ADDENDUM #1

EAST FERN AVENUE FENCE PROJECT ENGR-081220

JULY 29, 2020

Addendum #1 is being issued to reflect changes in the specifications, project drawings, and price sheet primarily due to the addition of gates at two other locations along East Fern Avenue.

DWG
SK-1

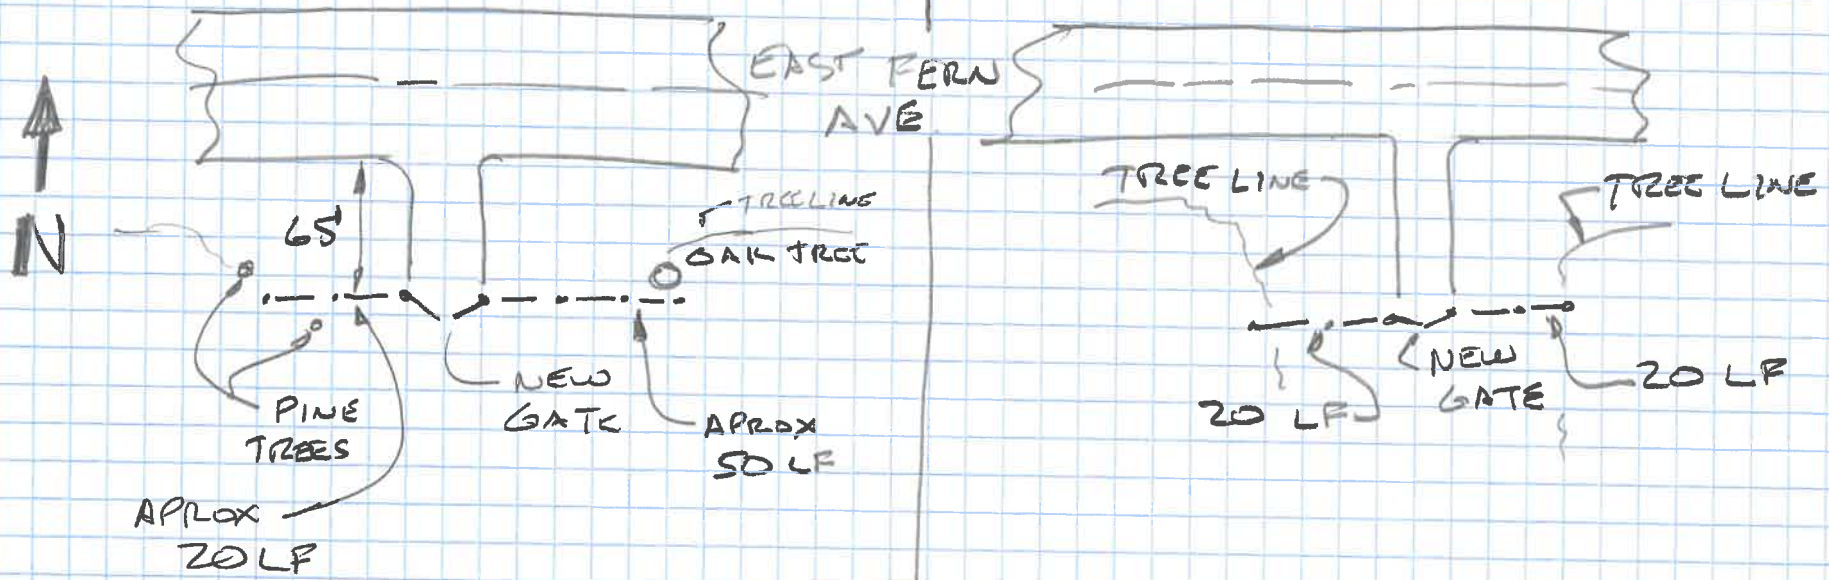
- 1) **Specifications** – These revised specifications replace the original specifications located on page 4 of the bid packet.
- 2) **Dwg-SK-1 and Dwg-SK-2** – These revised drawings replace the original drawing Dwg-SK-1 located on page 8 of the bid packet.
- 3) **Detail-01** – This revised drawing replaces the original Detail-01 sheet located on page 9 of the bid packet
- 4) **Plan Quantity Price Sheet** - Updated to reflect a change in estimated quantities and removal of price sheet item #6. This revised price sheet replaces the original price sheet found on page 10 of the bid packet.

REV 1 July 28

MAY
18
2020
REVISED JULY 23

DWG
SK-2

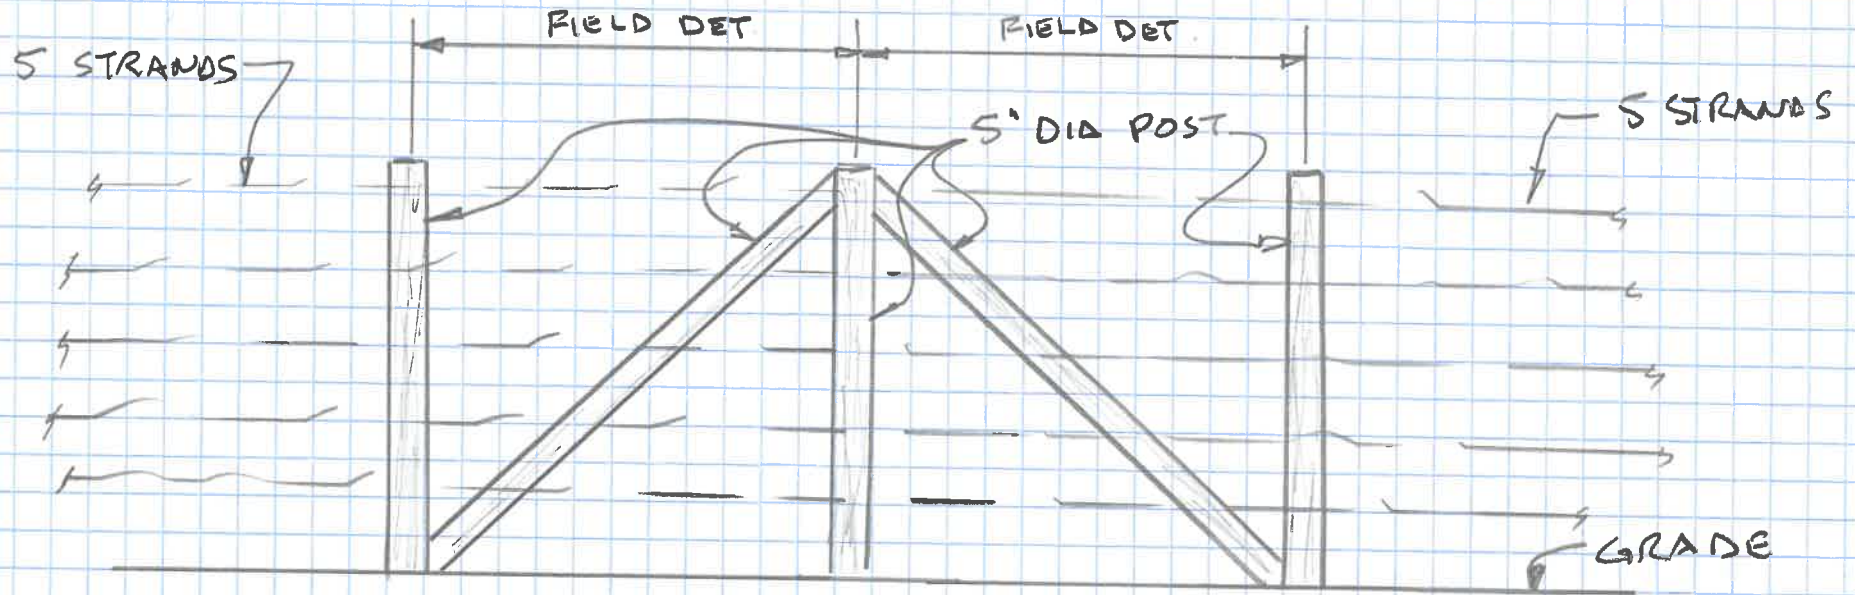
2ND GATE

3RD GATE
